CITY OF CHARLOTTESVILLE, VIRGINIA
CITY COUNCIL AGENDA

Agenda Date:	February 1, 2016
Action Required:	Make a determination to either uphold or overturn the decision of the Board of Architectural Review (BAR)
Presenter:	Mary Joy Scala, Preservation & Design Planner, Department of Neighborhood Development Services (NDS) Melanie Miller, Chair, BAR Carl Schwarz, Architect and Member, BAR
Staff Contacts:	Mary Joy Scala, Preservation & Design Planner, Department of NDS Alex Ikefuna, Director, NDS
Title:	200 W Main Street - Appeal of BAR decision to deny darkly tinted glass at Violet Crown Cinema

Subject: BAR Action Dec 15, 2015 - 200 W Main Street

**CITY OF CHARLOTTESVILLE
BOARD OF ARCHITECTURAL REVIEW
STAFF REPORT
December 15, 2015**

AGC Glass Calculator Performance Data

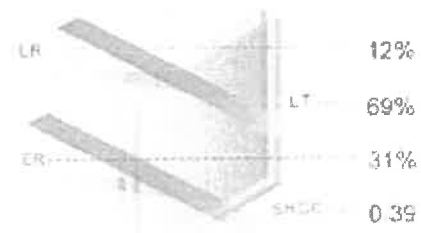
Configuration:	
Exterior Lite	1/4" (6 mm) Energy Select™ 40 Clear (2)
Airspace	1/2" (13 mm) Spacer
Interior Lite	1/4" (6 mm) Clear
Visible Light	
Transmittance (LT)	69%
Reflectance - Outdoors (LR)	12%
Reflectance - Indoors	12%
Solar Energy	
Transmittance	34%
Reflectance - Outdoors (ER)	31%
U.V. Light	
Transmittance	17%
Damage Weighted Index -ISO	0.533
U-Values	
Winter - Air / Argon	0.29/0.25
Summer - Air / Argon	
Other Values	
Solar Heat Gain Coefficient (SHGC)	0.39
Shading Coefficient	0.44
Relative Heat Gain - BTU/Hr/Sq. Ft.	92.83
Light to Solar Heat Gain Ratio	1.79

By the way, if I'm not mistaken, I'm pretty sure I remember Mike Stoneking mentioning PPG's Starphire glass for this project. PPG combines this with some of their Solarban products, but I understand it's also kind of expensive. <http://www.ppgideascape.com/Glass/Products/Low-E-Glass/SOLARBAN-Solar-Control-Low-e/SOLARBAN-72-Glass.aspx>

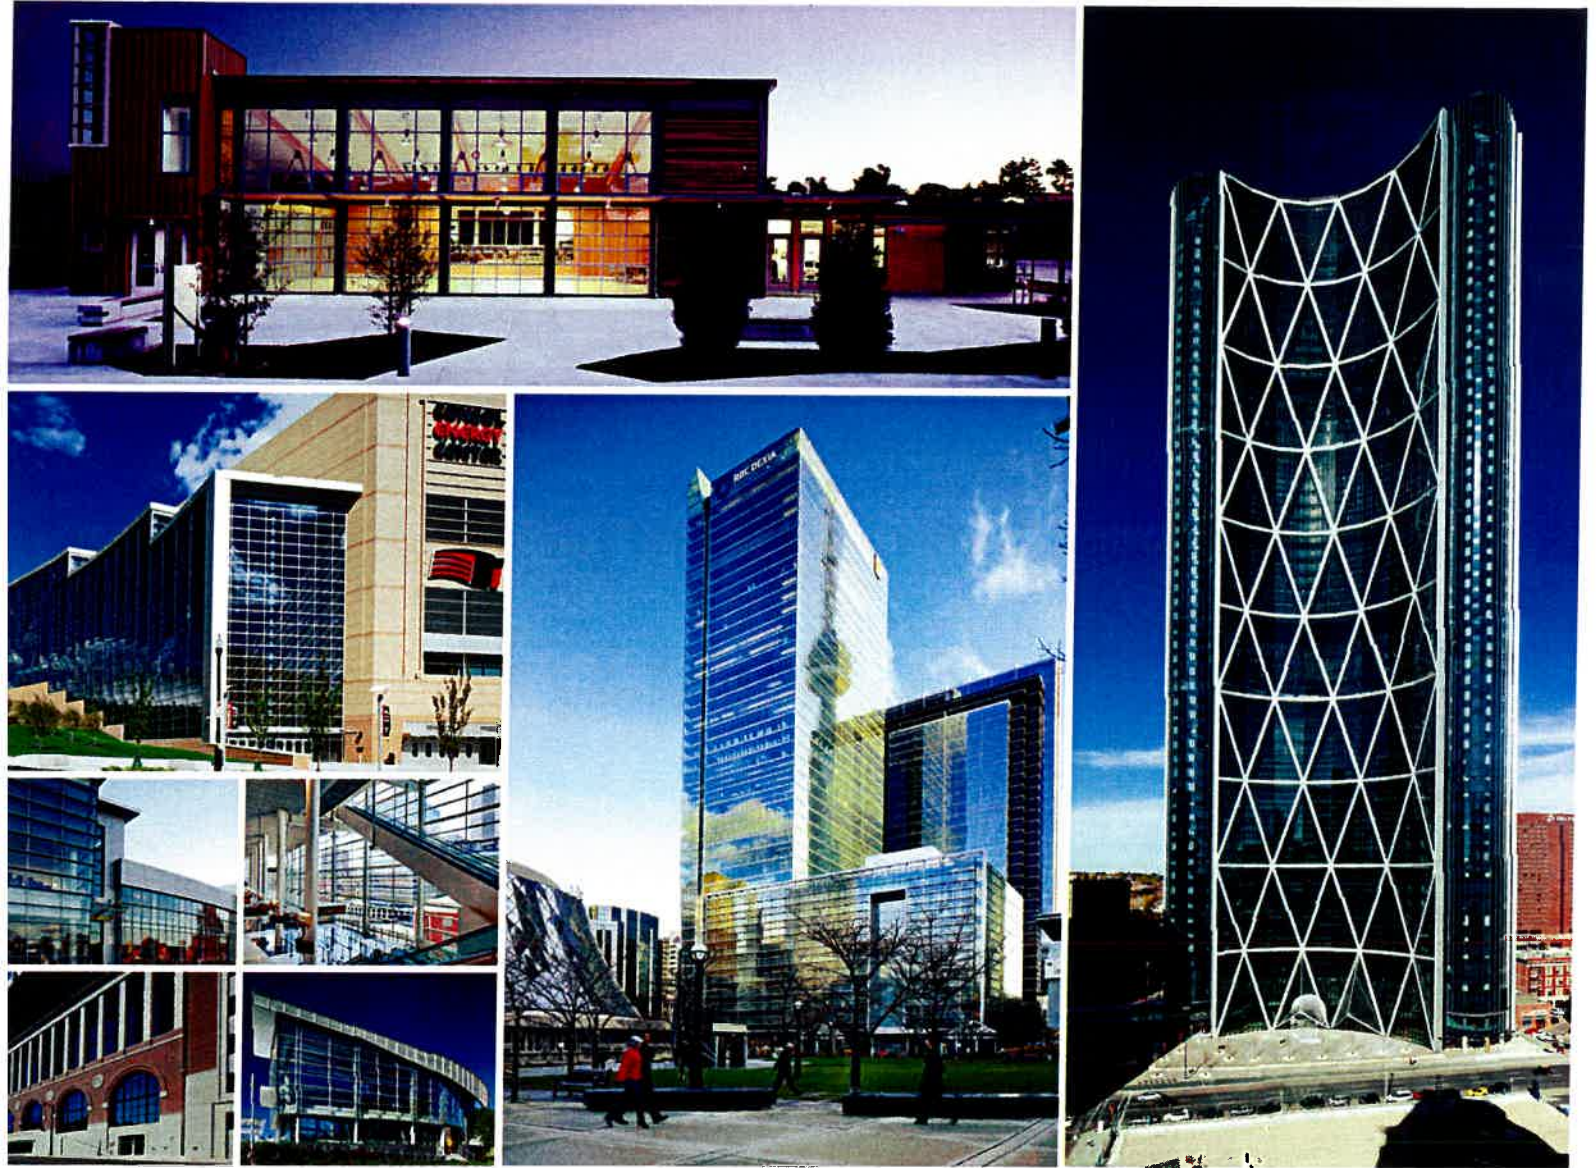
Added a drip edge to the bottom of the canopy to match the coping that runs along the top profile. Refer to exhibit ASD-9 for details.

Second Street Building Paint Color

The owner withdraws its proposal to paint the Second Street façade, however if the BAR desires this façade to be painted the Owner request input on the color selection.
